Access Compliance Report Public Rights-of-Way (Curb Ramps)

Main Street: HYDRANGEA_ST Cross Street: BARBERRY_ST Location: SW

ADA ID: RPAT211102150701 Ramp Type: Type 1 - Perpendicular Diagonal Initial Pass/Fail: Fail Overall Compliance: No Severity Score: 30

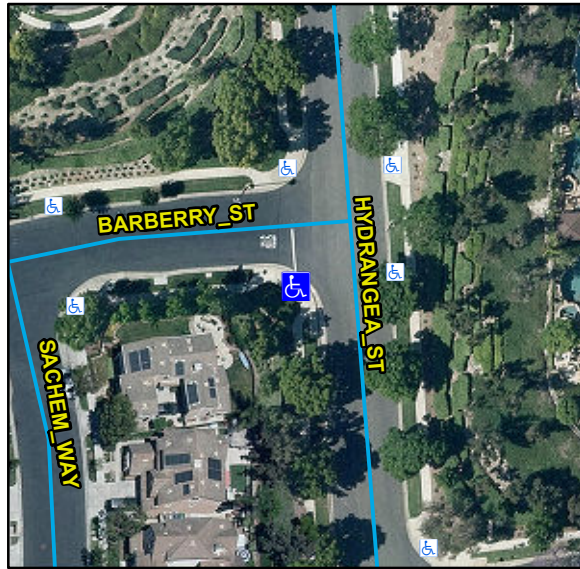
Compliance	Description	Data	Compliance	Description	Data
N/A	Ramp Length (in)	89	N/A	Flare Type LT	
Yes	Ramp Width (in)	60			N/A
Yes	Ramp Run Slope (%)	4.5	N/A	Flare Slope LT (%)	N/A
No	Ramp Cross Slope (%)	8.7	N/A	Flare Traversable LT	N/A
N/A	Landing Present	N/A	N/A	Flare Type RT	
N/A	Landing Length (in)	N/A			N/A
N/A	Landing Width (in)	N/A	N/A	Flare Slope RT (%)	N/A
N/A	Landing Run Slope (%)	N/A	N/A	Flare Traversable RT	N/A
N/A	Landing Cross Slope (%)	N/A	N/A	DWS Provided	N/A
N/A	Landing Movement Obstructed?	N/A	N/A	DWS Contrast	N/A
	Landing Movement Type	N/A	N/A	DWS Length (in)	N/A
N/A	Landing Shared	N/A	N/A	DWS Full Width	N/A
N/A	Clear Space	Yes	N/A	DWS Offset Left (in)	N/A
N/A	Clear Space To Crosswalk (in)	N/A	N/A	DWS Offset Right (in)	N/A
N/A	Marked Crosswalk 1	No	N/A	Marked Crosswalk 2	No
	Crossing 1 Direction	E		Crossing 2 Direction	N
	Marked Crosswalk 1 Width (in)	N/A		Marked Crosswalk 2 Width (in)	N/A

N/A	Ramp Inside Crosswalk 1	N/A	Yes	Ramp Inside Crosswalk 2	N/A
	Crossing 1 Slope (%)	4		Crossing 2 Slope (%)	4.5
	Crossing 1 Cross Slope (%)	7		Crossing 2 Cross Slope (%)	3.3
N/A	Gutter Ponding	N/A	No	Curb Slope	6.3
Yes	Gutter Lip Height (in)	0		Road Run Slope (%)	7.9
N/A	Gutter Run Slope (%)	N/A		Road Cross Slope (%)	1.3
N/A	Gutter Cross Slope (%)	N/A			
Yes	Overall Surface Condition: Acceptable		No	Perp Joint Present	No
	Cross Gutter Present?	No		Spandrel Present?	No
	Replace Cross Gutter?	N/A		Replace Spandrel?	N/A

Remove & Replace Curb Ramp With Two New Directional Ramps or Equivalent.

R304.2.2, R204.3, R304.5.3, STD 1115
